WSCC Highways Consultation Response, HTp Response Note

ARUN DISTRICT COUNCIL P/140/16/OUT

WEST SUSSEX COUNTY COUNCIL **DATE: 27th January 2017**
STRATEGIC PLANNING CONSULTATION

SUBJECT: **P/140/16/OUT - Outline application for access only - mixed use development comprising of up to 400 dwellings, a care home with up to 70 beds, a Local Centre comprising up to 2000sqm of A1/A2/A3/D1/sui generis floorspace, provision of land for a 1FE primary school (with sufficient space to ensure that it is expandable to 2FE), provision of land for a scout hut, safeguarding of land to help link the site to the Pagham Harbour Cycle Route & other community uses including public open space & allotments with some matters reserved. This application is a departure from the Development plan**

Pagham South Wider Area Highway Network Peak Hour Distribution Diagrams

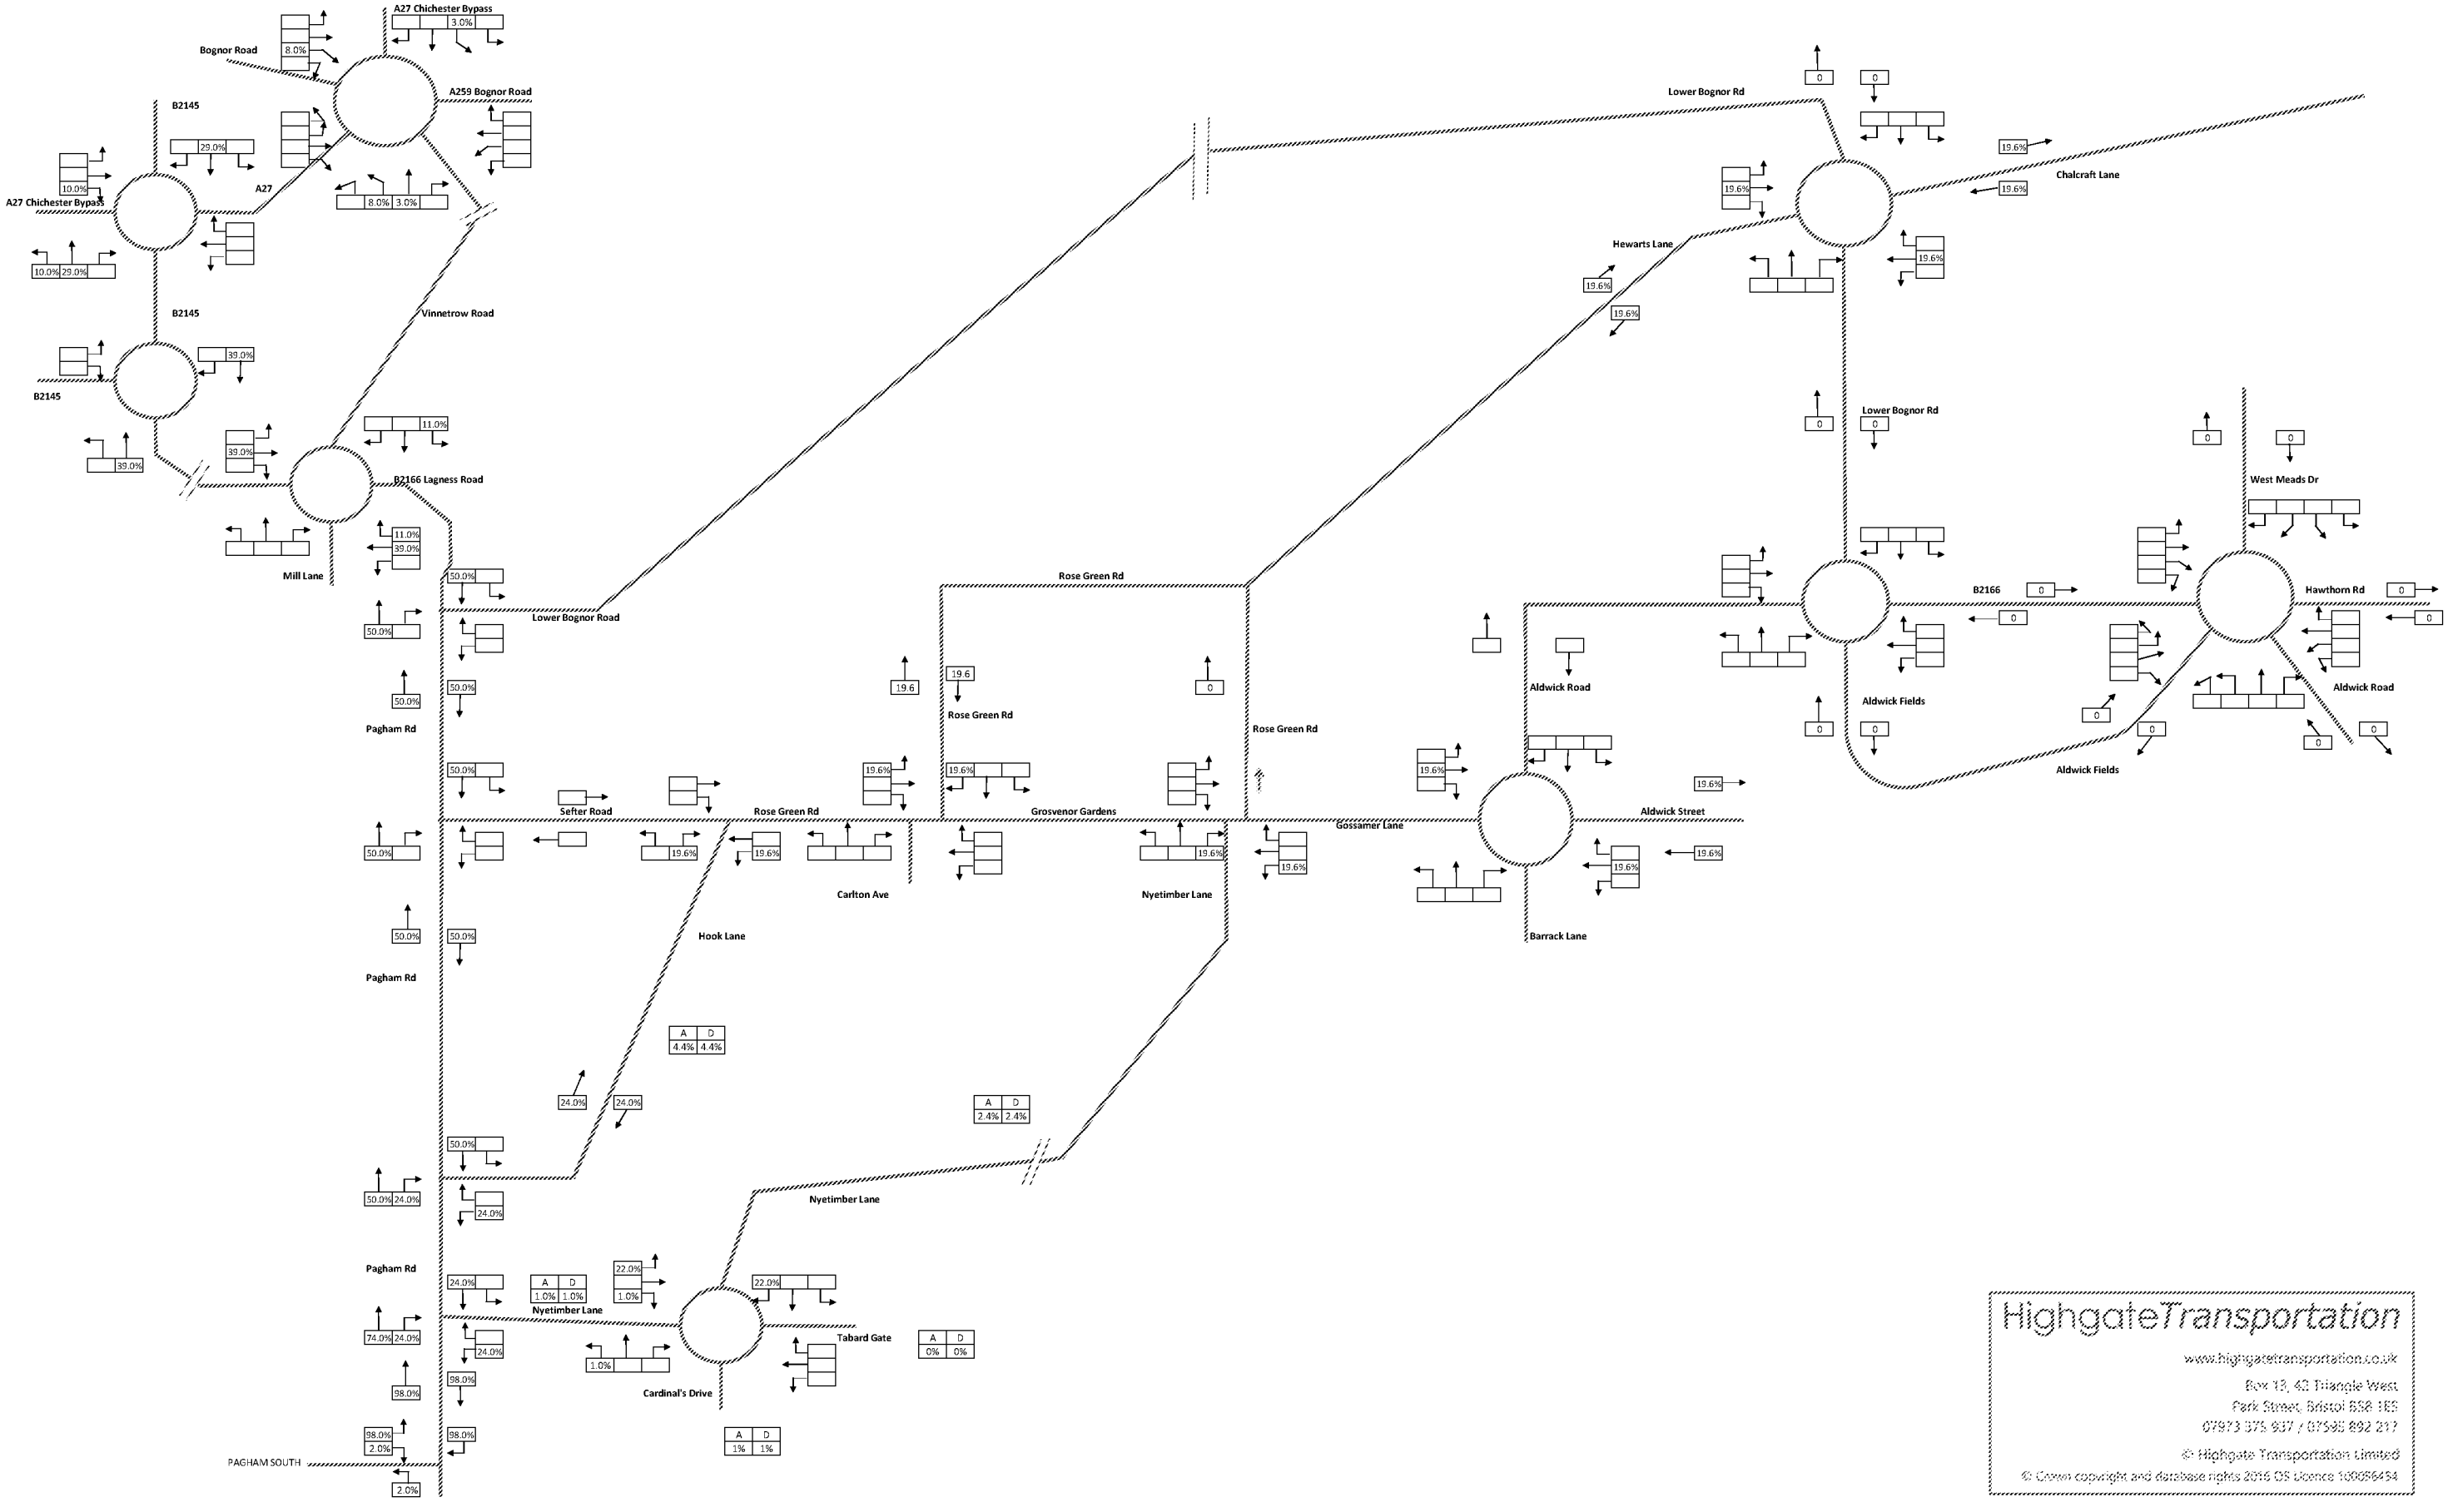
33. In summary, there are a various matters that require further information. A separate distribution drawing for the wider area should also be provided that includes south of Summer Lane development only traffic; at present the distribution diagrams include combined base and development traffic.

The revised Transport Assessment will include all relevant flow diagrams.
